Series 14-B Valve Retainer Improvement

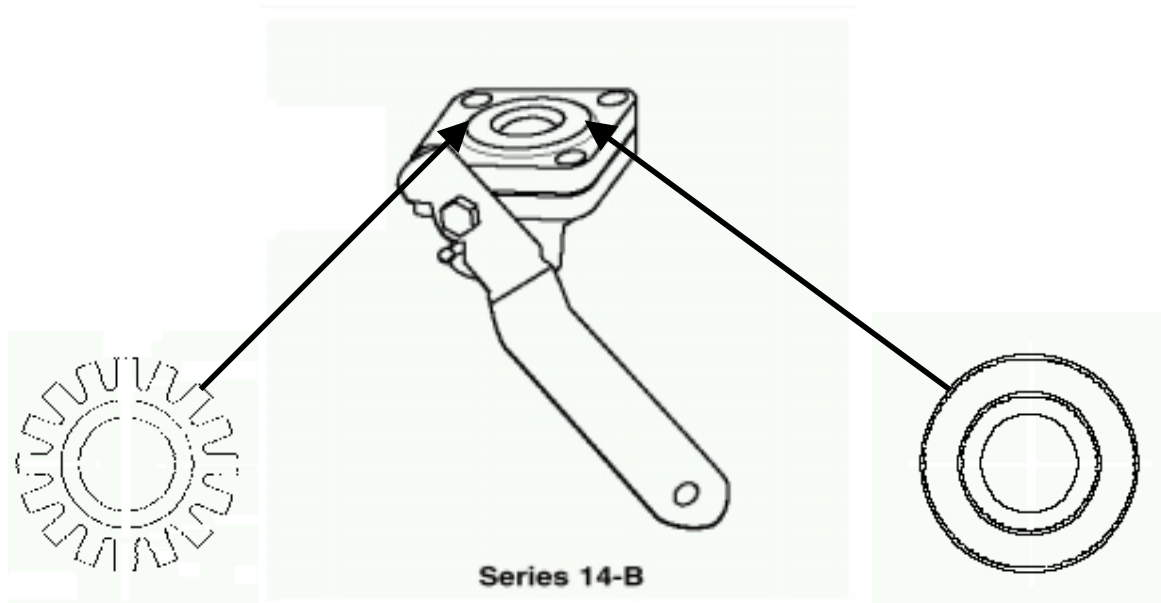
Effective May 1999, the Series 14-B ball type blow down valve includes a flat 304 stainless steel retainer. The new flat retainer replaces the copper “spider” design. In addition to being more corrosion resistant, the new design is also thicker, adding rigidity to the valve.

The diagrams below show the design change. The smaller drawings on either side are close-up pictures of the old (left) and new (right) retainer. New valves with a flat retainer are completely interchangeable with existing product.
